HOME2 SUITES FLOWOOD, MS 3rd FLOOR PANELS

- ☒ REVIEWED
- ☐ REVIEWED AND NOTED
- ☐ REVISE AND RESUBMIT
- ☐ REJECTED
- ☐ RETURNED - SUBMITTAL NOT REQUIRED

Whisonant Engineering Services, LLC

Shop Drawings by:
HILLMAN ENTERPRISES, INC.
P.O. Box 106
Graham, AL 36263
PHONE: (256) 449-9261

PNL.#: 3-06d QTY: 2

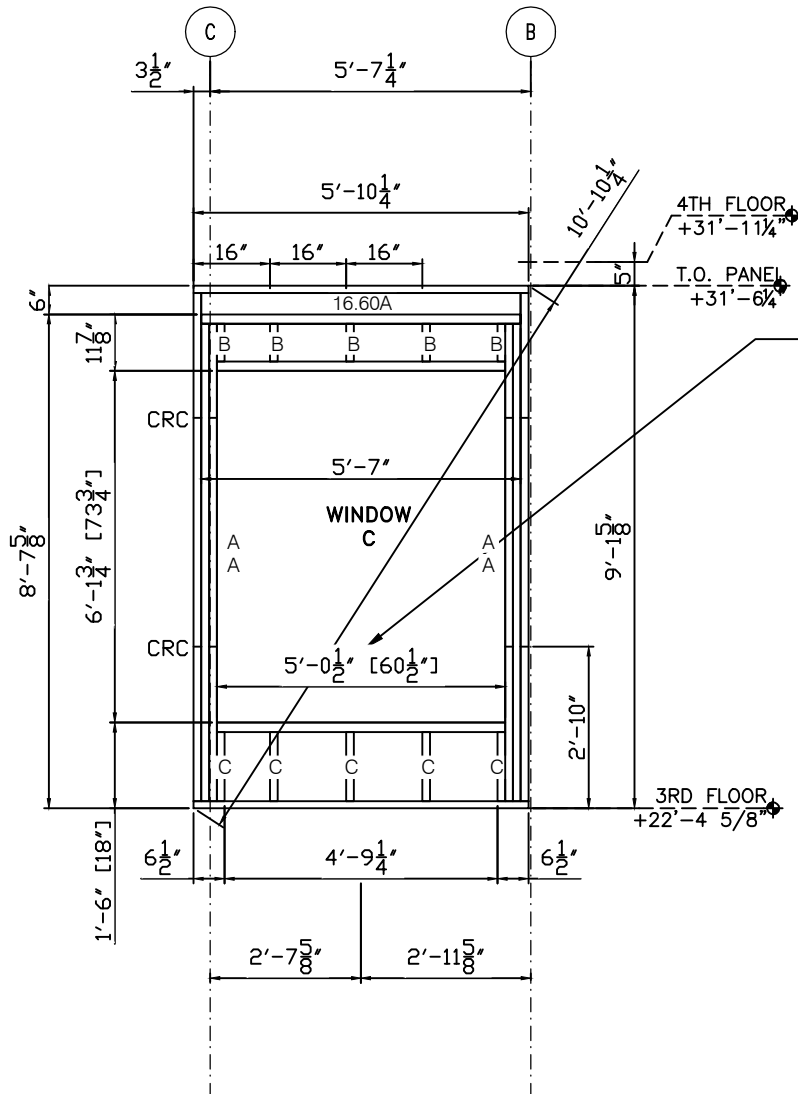
NOTE: BECAUSE OF REQUIRED SUPPORT STUDS, 60 1/2" CANNOT CENTER BETWEEN COLUMN LINES

PNL.#: 3-22c QTY: 1

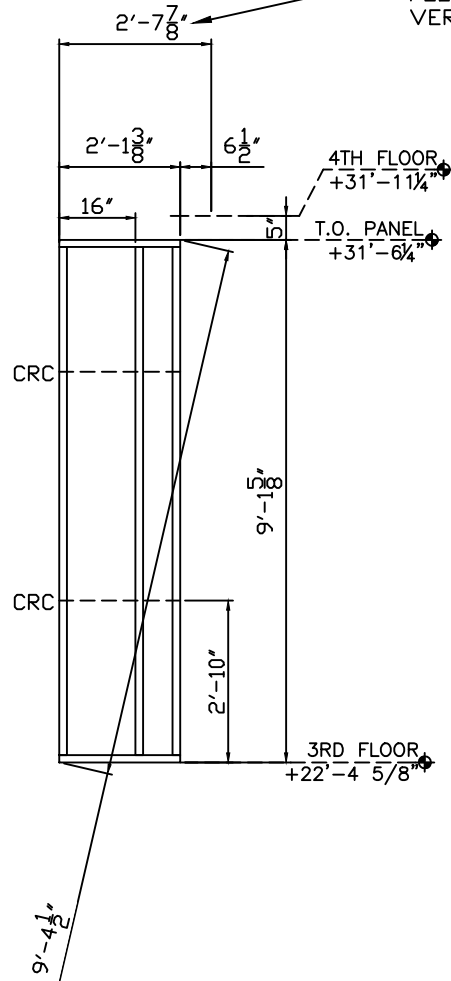
NOTE:
PLEASE
VERIFY

PNL.#: 3-23d QTY: 1

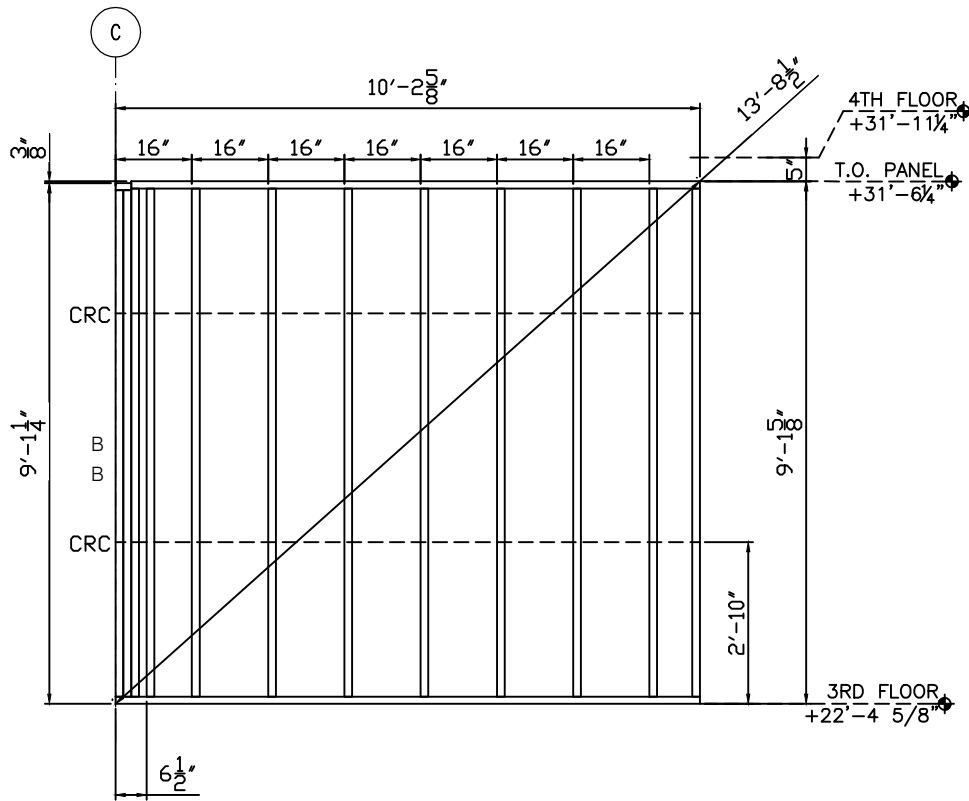
ADJACENT TO A PANEL WITH A VERIFICATION REQUEST

PNL.#: 3-27e QTY: 2

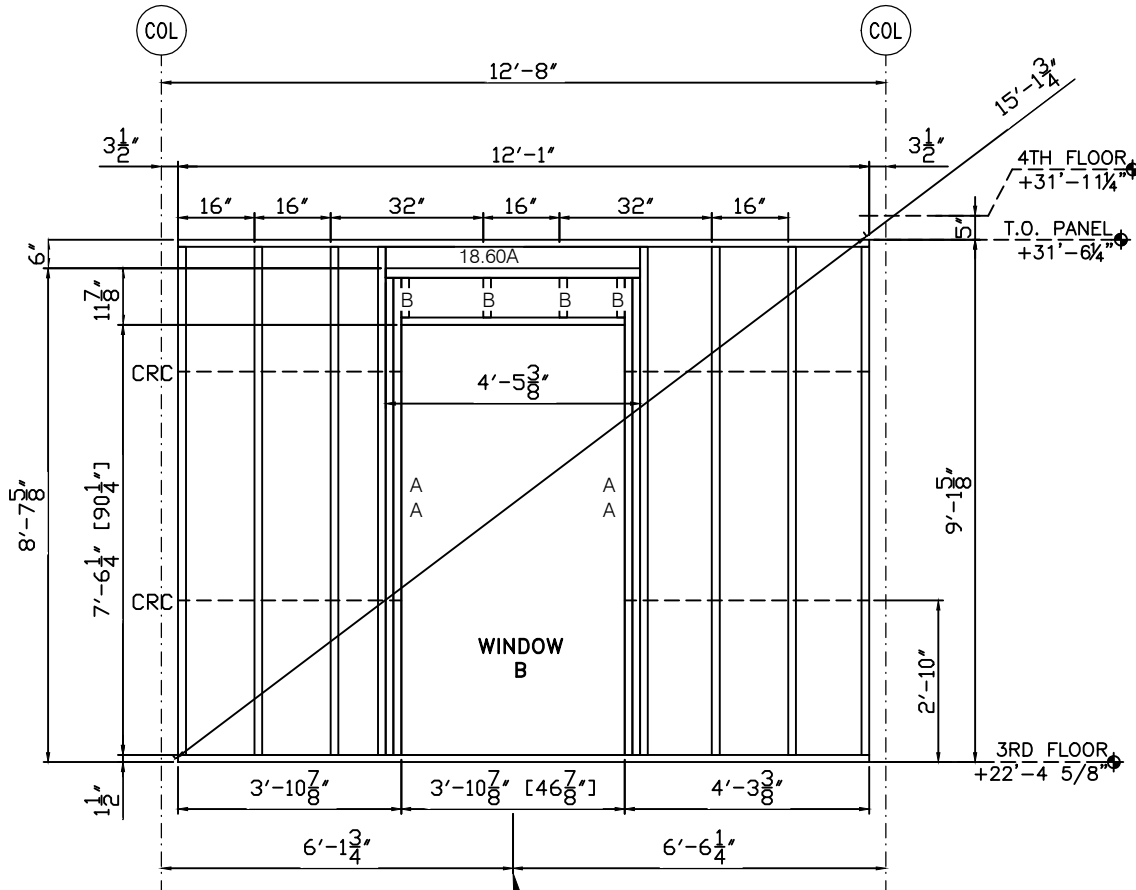
NOTE:
THIS WINDOW NOT CENTERED
TO ALIGN WITH WINDOW BELOW.
SEE 1-51e.

PNL.#: 3-28e QTY: 1

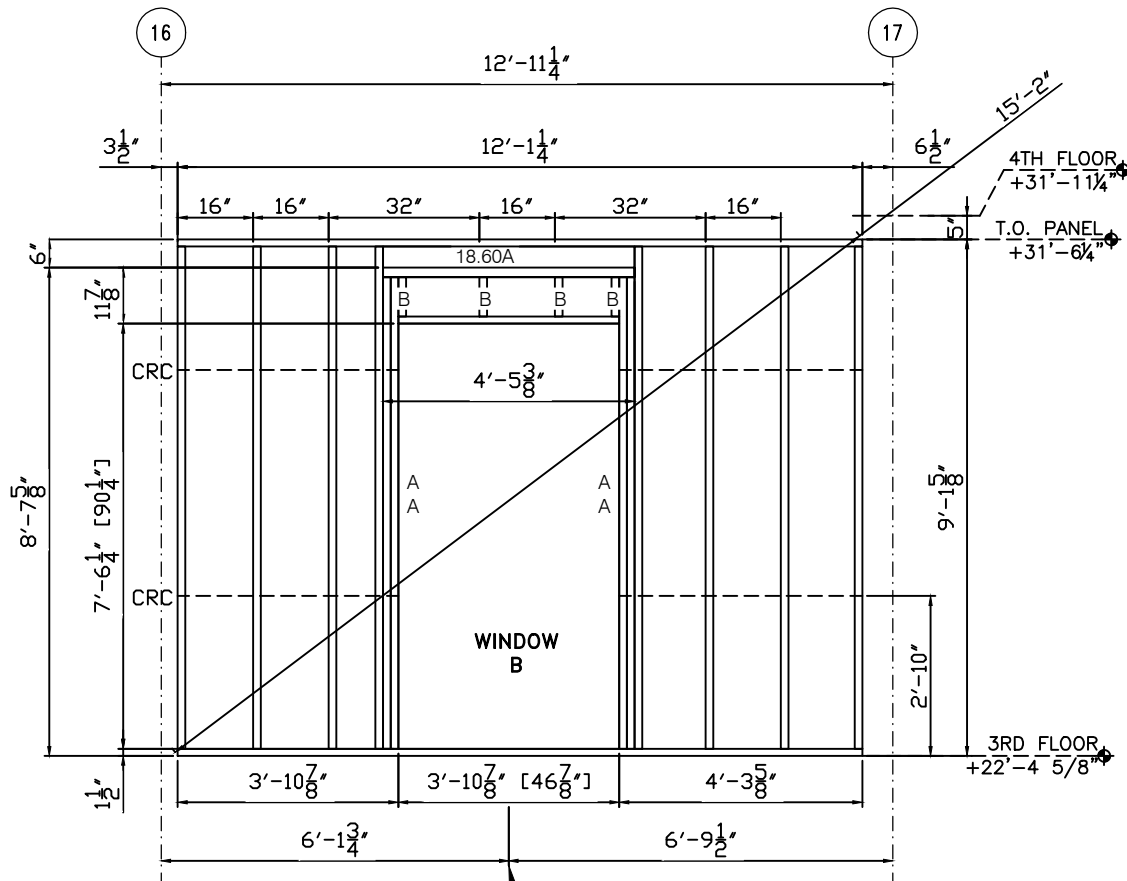
NOTE:
THIS WINDOW NOT CENTERED
TO ALIGN WITH WINDOW BELOW.
SEE 1-51e.

PNL.#: 3-48c QTY: 2

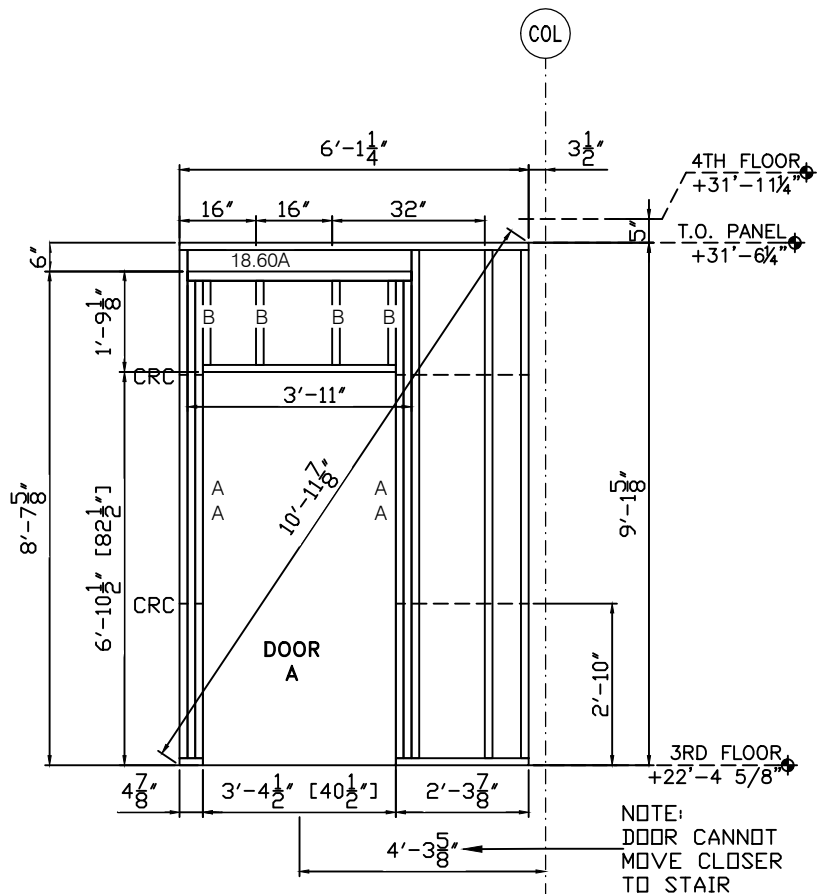
NOTE:
DOOR CANNOT
MOVE CLOSER
TO STAIR
